**PLANNING DIVISION REPORT  
DEPARTMENT OF PLANNING AND COMMUNITY  
AND ECONOMIC DEVELOPMENT  
Of May 2, 2007**

**RE: I.D. # 06309, Demolition Permit – 1506-18 N. Stoughton Road, et al.**

SUBJECT: 1518 North Stoughton Road Demolition

Map 14: Proposed East Washington-North Stoughton Road diamond interchange

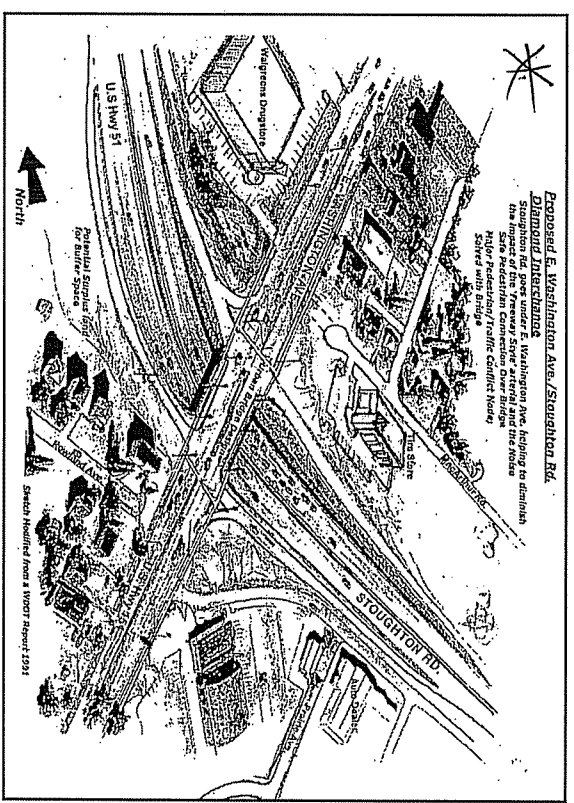
- ✓ Continue to explore the likelihood of a North Stoughton Road underpass at the intersection of East Washington Avenue and North Stoughton Road. Construction of an underpass would facilitate safe pedestrian crossing at the intersection as well as improve the overall appearance of this six-lane intersection (see Map 14).
